# B86486-01 CDAX unit Release Notes

Document version: 3.12f

B86486-01 CDAX unit

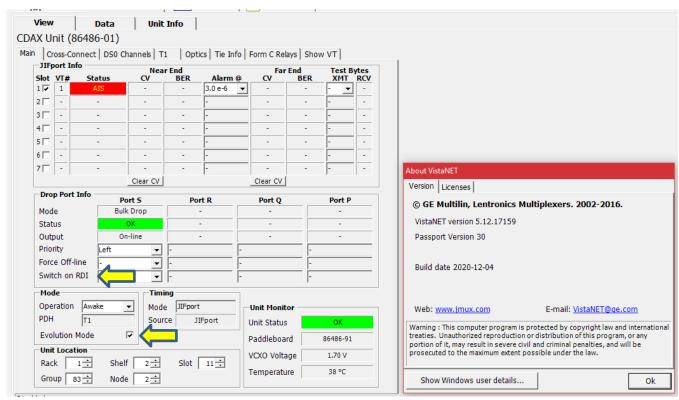
Customers shall enable "Evolution Mode" in the Main CDAX Unit's VistaNET GUI in both left and right cards at these locations.

Enable 'Evolution Mode' and 'Switch on RDI' for VT's facing an Evolution Module
